Access Compliance Report

Public Rights-of-Way

(Curb Ramps)

Intersection ID: N/A	Main Street: ARBOR_LOOP_DR	Cross Street: POTOMAC_RIVER_PY	Location: NW
ADA ID: 8DB8E69D1ED5	Ramp Type: Directional	Initial Pass/Fail: Pass	Overall Compliance: No
		Severity Score: 0.25

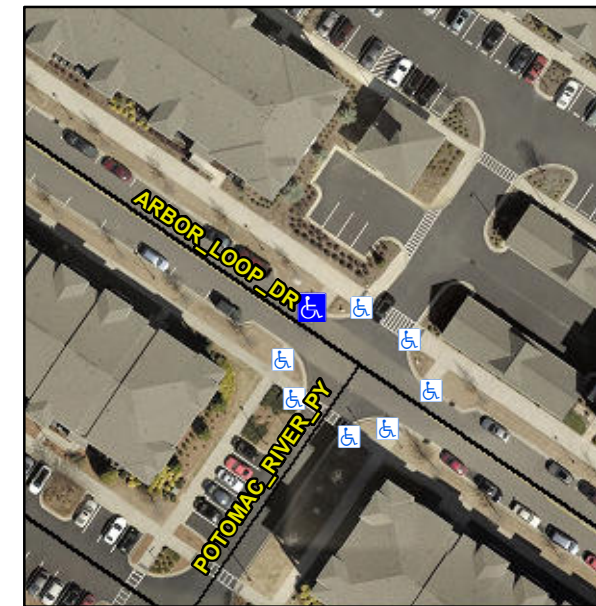
R304.5.3

Compliance	Description	Data	Compliance	Description	Data
N/A	Ramp Length (in)	139.0	Yes	Grade Break?	Yes
Yes	Ramp Width (in)	82.0	No	Grade Break Slope (%)	5.8
Yes	Ramp Slope (%)	7.2	Yes	Grade Break XSlope (%)	1.9
No	Ramp XSlope (%)	3.6			
Yes	Flare Type LT	N/A	Yes	Flare Type RT	N/A
N/A	Flare Slope LT (%)	N/A	N/A	Flare Slope RT (%)	N/A
N/A	Flare Traversable LT?	No	N/A	Flare Traversable RT?	No
Yes	Landing Length (in)	120.0	Yes	DWS Provided?	Yes
Yes	Landing Width (in)	95.0	Yes	DWS Contrast?	Yes
Yes	Landing Slope (%)	0.9	Yes	DWS Length (in)	24.0
Yes	Landing X Slope (%)	2.4	Yes	DWS Full Width?	Yes
N/A	Landing Curb? (Y/N)	N/A	Yes	DWS Offset LT (in)	20.0
N/A	Shared Landing?	No	Yes	DWS Offset RT (in)	0.0
Yes	Gutter Ponding?	No	Yes	Gutter Slope (%)	0.7
Yes	Gutter Lip Ht (in)	0.0	No	Gutter X Slope (%)	4.7
N/A	Painted X Walk1?	No		Road Slope (%)	0.1
	X Walk 1 Direction	To S		Road X Slope (%)	2.8
	X Walk 1 Width (in)	N/A		Clear Space?	Yes

Remove & Replace Entire Ramp.
Remove & Replace Gutter.
